Ref: AFS-10-0020
Document No. TP3(51199)GLC012610

SUBJECT: Request for Additional Information on TRUPACT-III, Docket No. 71-9305, TAC No. L24403

Specific responses to each NRC Request for Additional Information (RAI) are provided in Attachment B, which include references to the applicable SAR sections. To assist the NRC staff in its review of the revised application, a summary of the changes to the packaging general arrangement drawings is provided in Attachment C.

Layout of Extended Thermal Model for CSA Wall

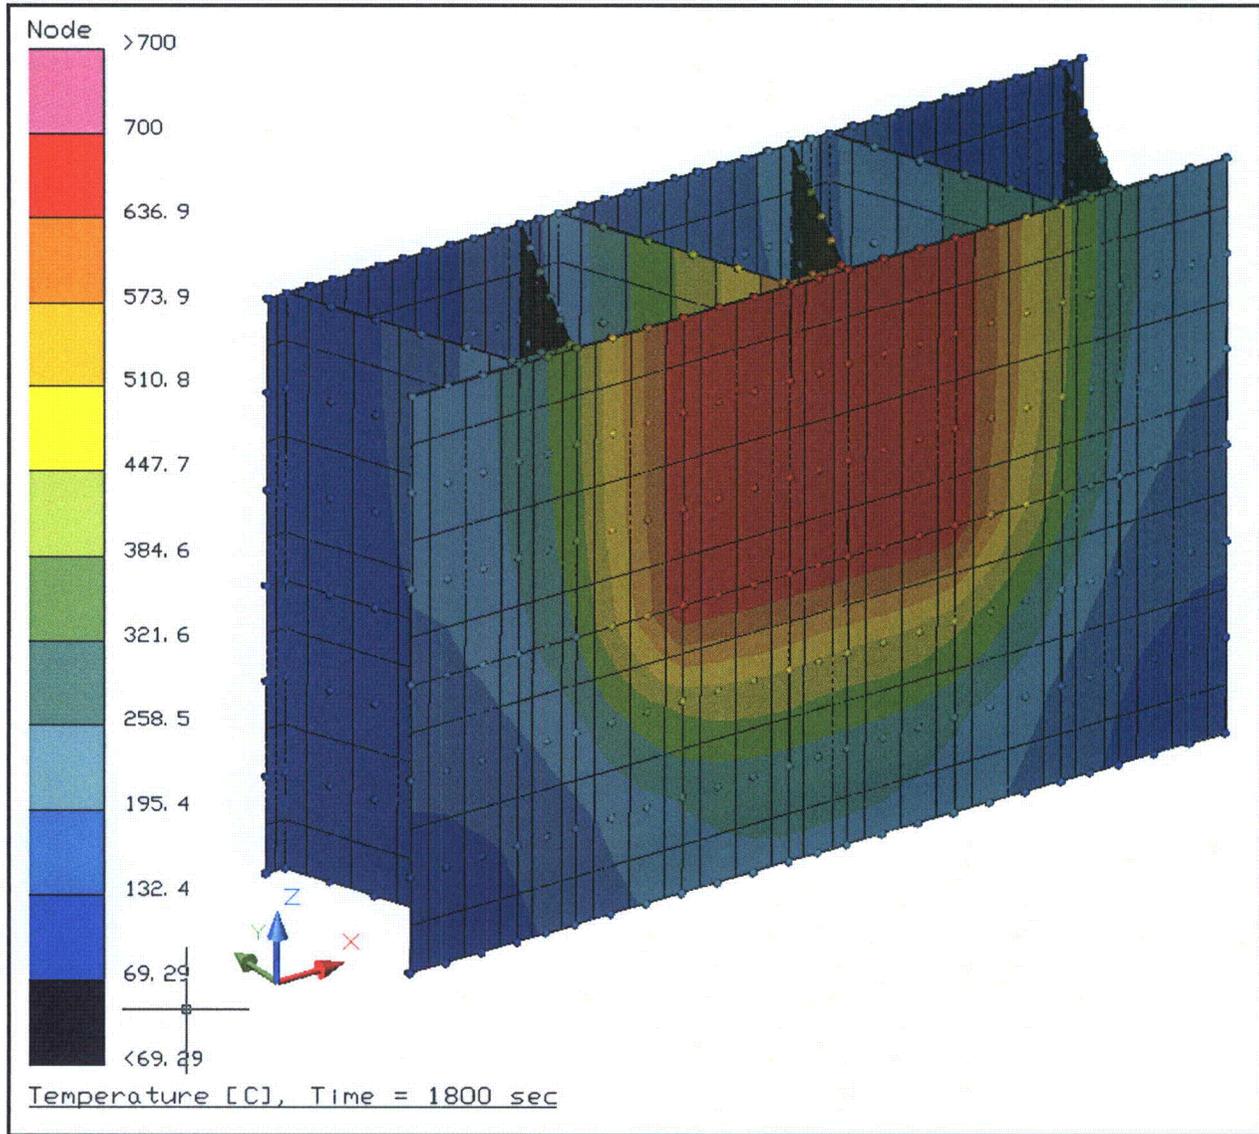
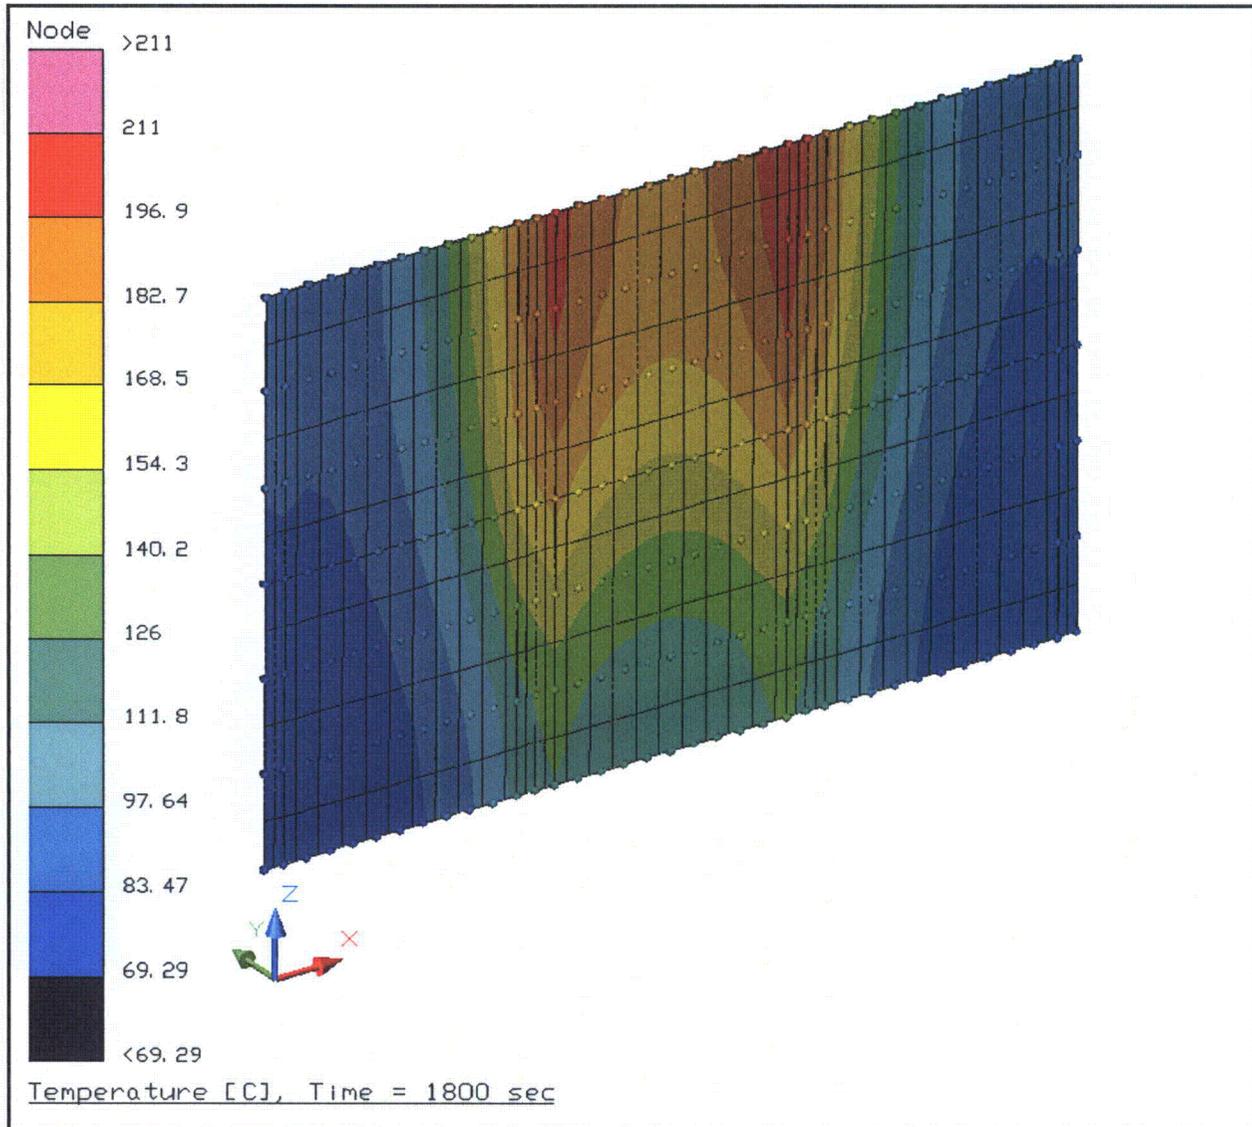
- 3.11 Explain and justify why the CSA stiffeners don't conduct and radiate heat to produce a higher localized temperature than 150 °C on the containment sheet of the CSA as shown on Figure 3.4-1 "Temperature Response of TRUPACT-III Package to HAC Fire Event," when the corresponding structural sheet that is only 124 mm away is at 714 °C.

Response: Conductive heat transfer within the CSA structure is limited by the spacing and size of the stiffeners (i.e., 4 mm) and the thermal conductivity of the UNS S31803 stainless steel. The stiffeners also block direct radiation exchange between the inner and outer sheets of the CSA structure. When combined with the relatively low emissivity of the stainless steel surfaces, the presence of the stiffeners significantly reduces the principal heat transfer mechanism during the high temperature HAC event. Additionally, it should be noted that the referenced temperature difference occurs during a transient event. The temperature difference would be much smaller for steady-state conditions.

In responding to this comment, it was noted that the predicted peak structural sheet temperature of 714 °C exceeded the temperature range of the effective thermal properties for the corrugated wall structure previously presented in Table 3.2-2. As such, the previous HAC thermal model did not fully capture the non-linear effect of temperature during the HAC event. To correct this, the effective thermal properties were extended (see revised Table 3.2-2) to a bounding temperature range and the HAC thermal evaluation repeated. The resultant peak CSA containment sheet temperature increased from 151 to 222 °C, while the peak CSA structural sheet temperature decreased from 714 to 689 °C due to the higher heat transfer rate between the structural and containment sheets.

Verification of the SAR evaluation results is provided through use of an extended version of the thermal model used to establish the effective thermal properties of the CSA wall structure (see SAR Appendix 3.5.2.4, *Effective Thermal Properties for Corrugated Wall/Lid Structures*, for a description of the model). This extended thermal model joined six (6) segments of the

model depicted in Figure 3.5-11 to form a simulated wall segment that is 492 mm wide by 328 mm high. A transient boundary temperature condition that varied from 55 °C at time = 0 to 700 °C at time = 900 sec was applied to the structural sheet of the top, center 164 mm x164 mm sub-segment of the structural wall model to simulate the combined radiative and convective heating on a limited portion of the CSA's surface during the HAC event due to damage caused by the puncture bar attack. The proportion of the sub-segment to its neighboring segments is similar to the portion of the CSA surface exposed by the puncture bar attack.

The 700 °C boundary condition was then maintained for the final 900 seconds of the transient. Adiabatic conditions are assumed on the remaining five (5) segments of the structural sheet to conservatively simulate the limited heat transfer into the polyurethane foam that covers the CSA, while a radiation boundary condition to a 55 °C sink temperature is applied to the containment sheet to simulate the CSA's interaction with the payload cavity.

The figures below illustrate the extended thermal model and the temperature distribution within the simulated CSA wall structure at the end of the simulated 30-minute fire transient. As noted from the figures, the peak structural sheet temperature is 700 °C which bounds that predicted by the HAC evaluation, while the predicted peak containment sheet temperature is 211 °C. This predicted peak containment wall temperature level is consistent with that seen by the HAC evaluation of the TRUPACT-III package. An examination of the predicted temperature distribution on the containment sheet demonstrates how the V-stiffeners act to restrict the heat flow into the containment sheet under the transient high heat flux conditions that exist for the portion of the CSA surface exposed by the puncture bar attack.
